Amendments to the Drawings

REMARKS

Annotated Drawing Showing Changes
 Sheet 1 of 1
 Appl. No. 10/762,633

FIG. 7 (PRIOR ART)

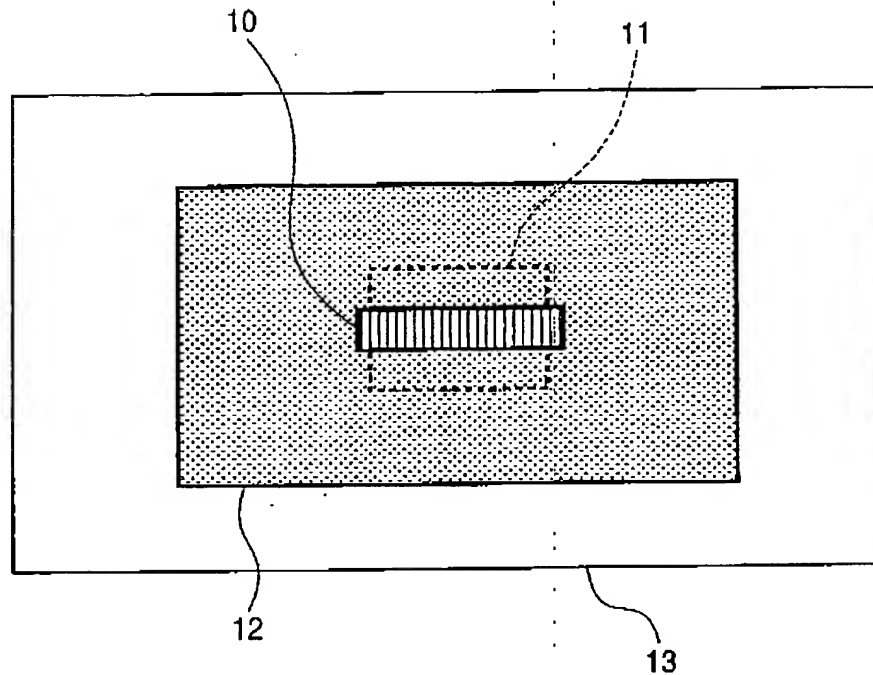
The Examiner has objected to applicant's FIG. 7 and required FIG. 7 to be designated by a legend such as -Prior Art - because only that which is old is illustrated. Applicant has amended applicant's FIG. 7, as shown in the Replacement Drawing and the Annotated Drawing Showing Changes, to include a legend "PRIOR ART," as suggested by the Examiner. The Examiner's objection is therefore obviated.

The attached Replacement Sheet of drawings includes changes to FIG. 7. This sheet, which includes FIGS. 6 and 7, replaces the original sheet including FIGS. 6 and 7. In FIG. 7, a legend "PRIOR ART" has been added.
